RE: Shepard Development LLC - Site Plan Review and Variances – Files #15-007994 and 15-022204

# NPS COMMENTS

## BUILDING HEIGHT VS FLOORS

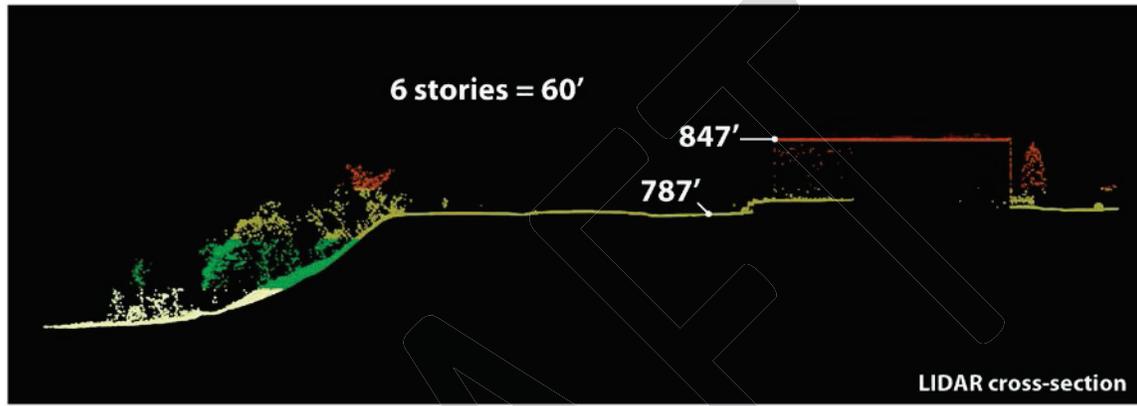
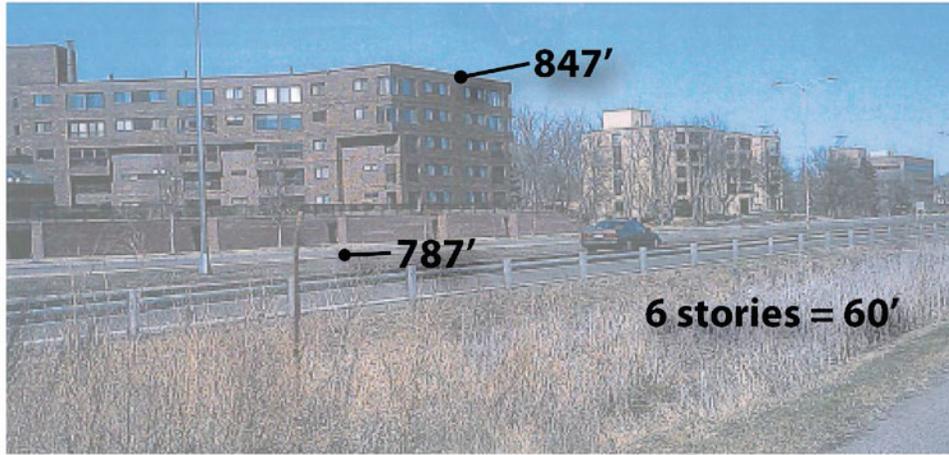
The staff report and variance request from the developer use building height and number of floors/stories interchangeably. This is confusing and misleading. The variance would not grant additional floors, it would grant additional height. Based on the developers drawings, the height of different floors within the building vary up to 30% (10'-14')! Other apartment buildings along Shepard Road are used to justify the height variance. The height of those buildings is never mentioned, but instead the number of floors is. The building height of these buildings should be compared, not the number of floors.

## BUILDING 2

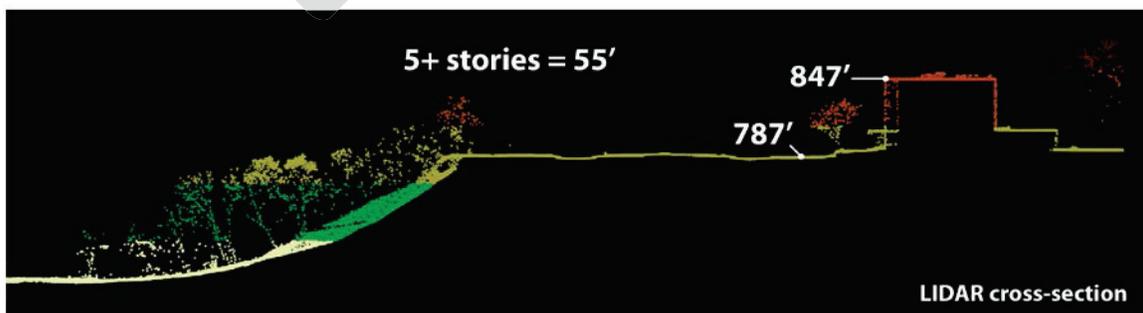
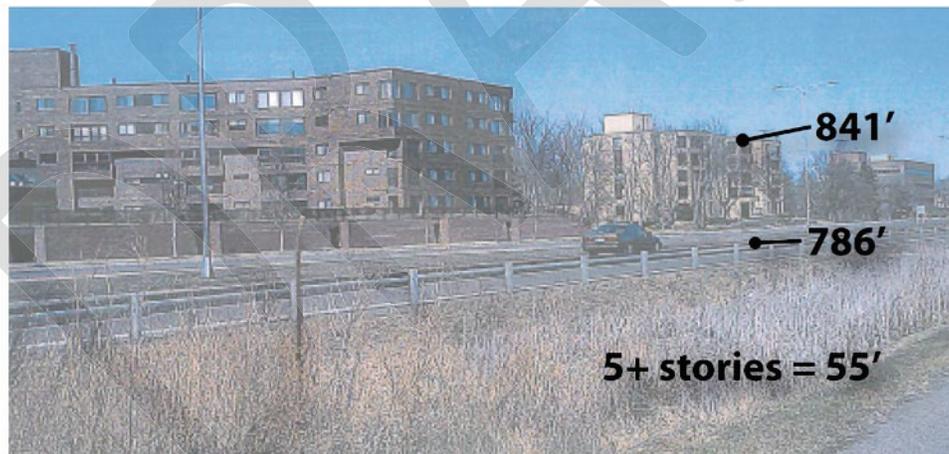
We do not find the other apartments identified along Shepard Road to be comparable to this proposal however. Number of stories, not building height, is used to justify the comparisons which can be misleading. We analyzed the building heights of the compared buildings based on available LIDAR data. That analysis is below.

## UPPER LANDING

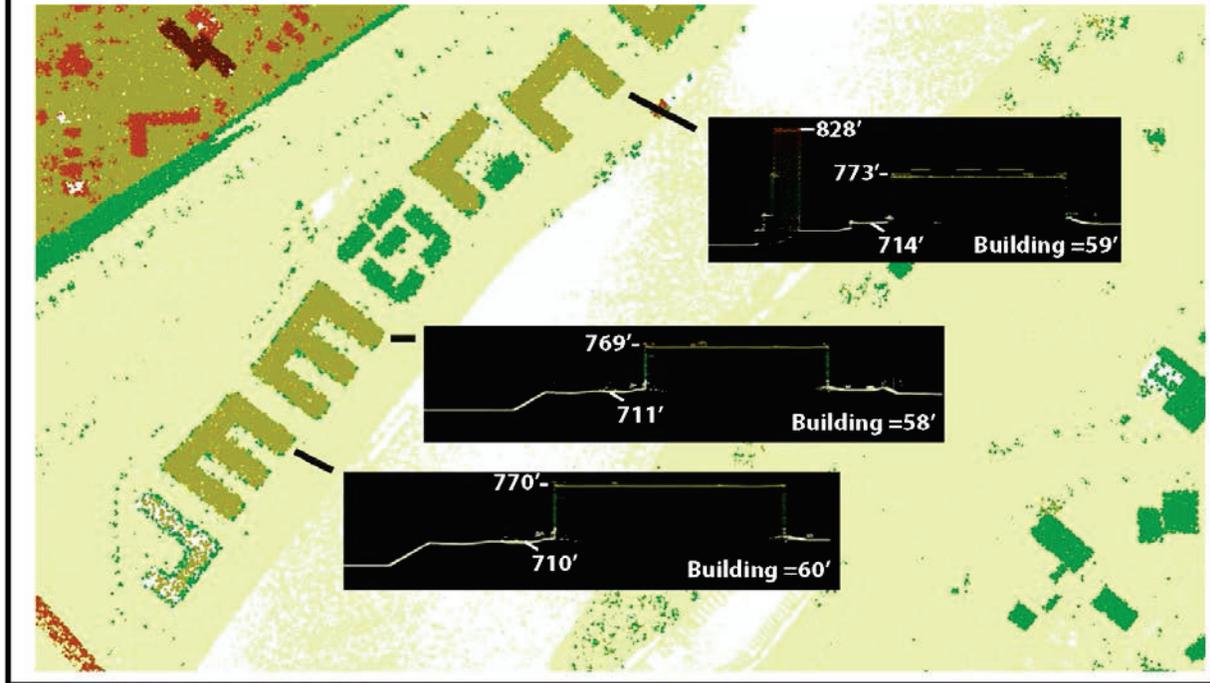
The proposed 73' building is up to 25% larger than the apartments that are used to justify the additional height. That is not comparable. This again emphasizes how the use of floors/stories is misleading.
